RE: Hollywood on Severn, Lot E, Plat A  
6 Fetter Lane  
Severna Park, MD 21146  
TM 31 BLK 3 P 387, R-5 Zoning, Council District 5

On behalf of the property owner, M.A.F and Associates, LLC is submitting a variance application for the above-mentioned project. The property owner is proposing to submit a variance application to allow disturbance within slopes greater than 15% in the Critical Area, the associated 25' buffer as well as developing within the 100' buffer to mean high water. This request is being made to allow for the construction of a wood deck and ramp to grade. These new decks will be constructed in the same location as the existing raised concrete patio. With the existing house lying mostly within the 100' buffer, there is no way of constructing the new wood deck without having development occur within the buffer. Since we are required to show a minimum 10' perimeter limit of disturbance and the location of the house with regards to the steep slopes, the plan shows impacts to steep slopes and the 25' steep slope buffer. This proposal will require a variance to allow development within the 110' buffer as well as within slopes greater than 15% in the Critical Area and

**SITE DEVELOPMENT PLAN**

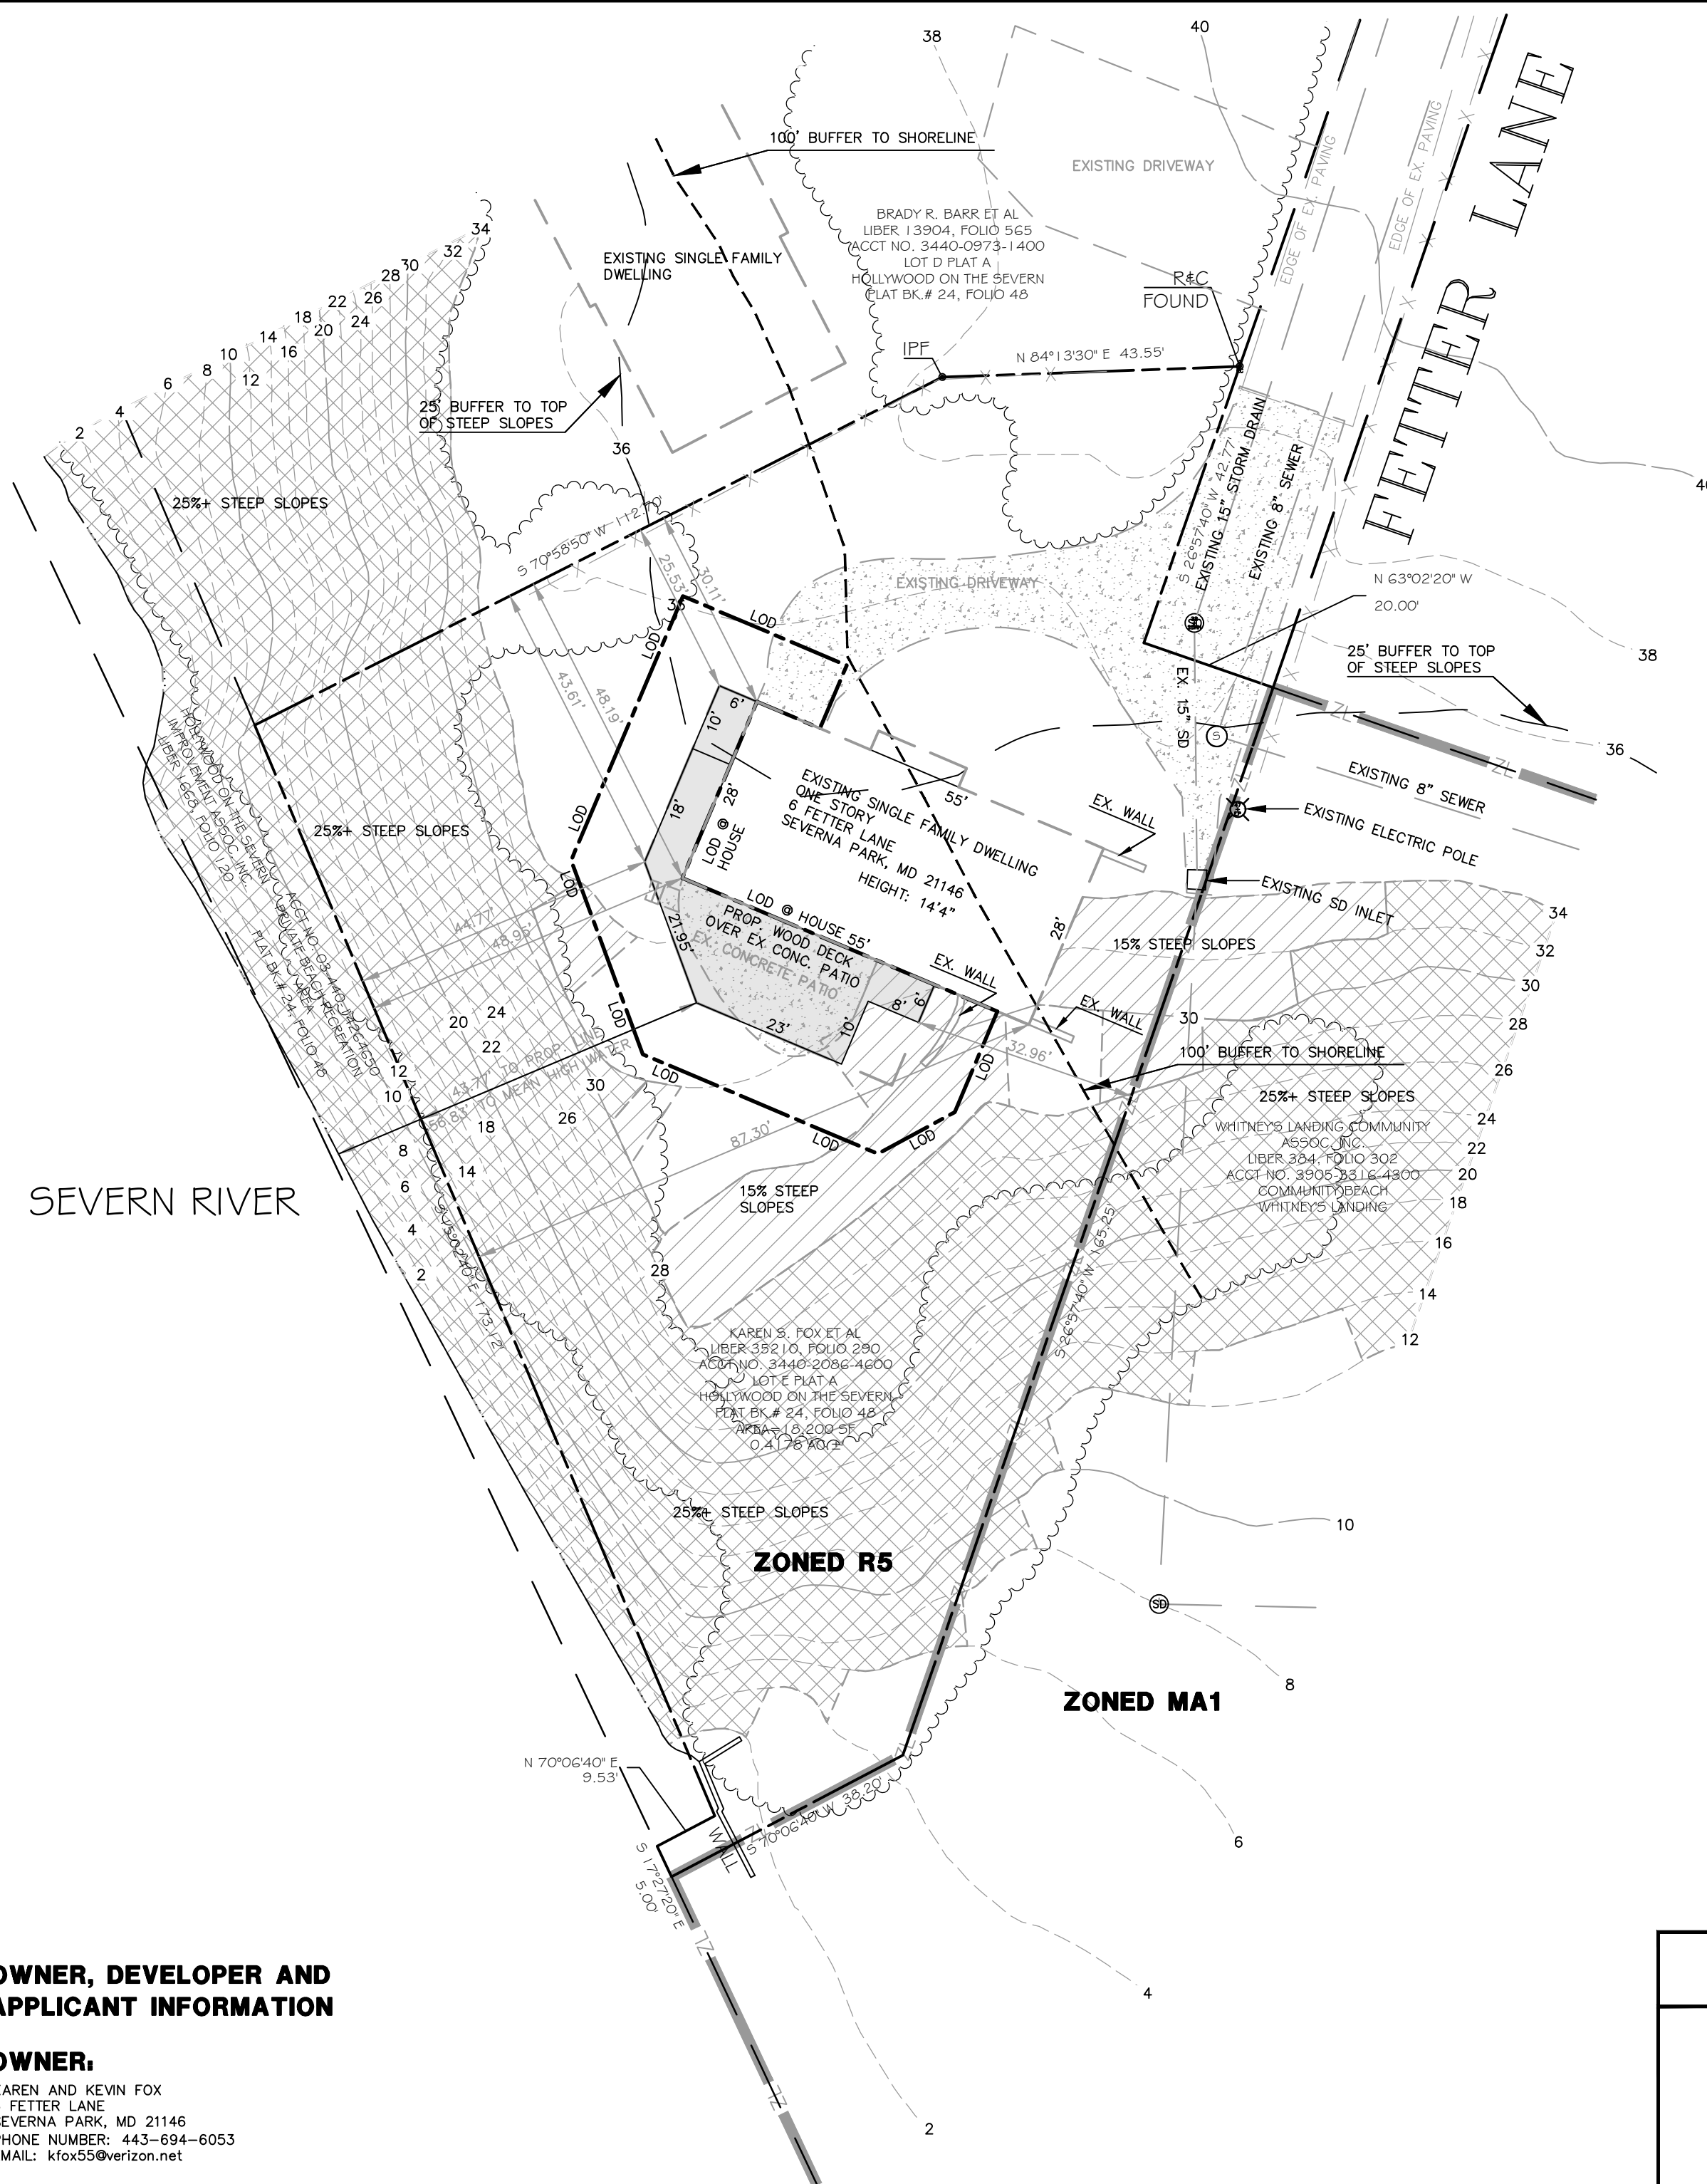
The Critical Area Team commented that they would support the in kind replacement/ repair of the existing patio only. No additional development should be placed within the buffer on this property. The Team advises that the Critical Area Team and the Forestry Division of the Office of Inspections and Permits can work with the property owner to install a fence to address the safety concerns as well as to develop a planting plan to address any erosion issues.

The Zoning Administration Section concurs with the Critical Area Team regarding the proposed critical area variance. Additionally, the variance site plan must show the 100-foot buffer, the steep slopes, and their associated 25-foot slope buffer. The site plan must also show the zoning line between the R5 portion of the lot and the MA 1 portion of the lot. The existing house is currently located entirely within the R5 portion of the lot, and the proposed deck must remain in the R5 portion of the lot.

**Our response:** The proposed deck size has been reduced to be primarily over the existing raised concrete patio. The area of proposed decking outside of the existing raised concrete patio allows for safe access from the house. The owner will work with the Department of Inspection and Permits for the required planting plan to address erosion issues.

**Our response:** The site plan has been revised to include the 100-foot buffer, the steep slopes, and their associated 25-foot slope buffer. The zoning line has been added to the site plan. The proposed deck is located entirely within the R5 portion of the lot.

The deck size has been reduced in size as requested. The variance letter has been revised as required.
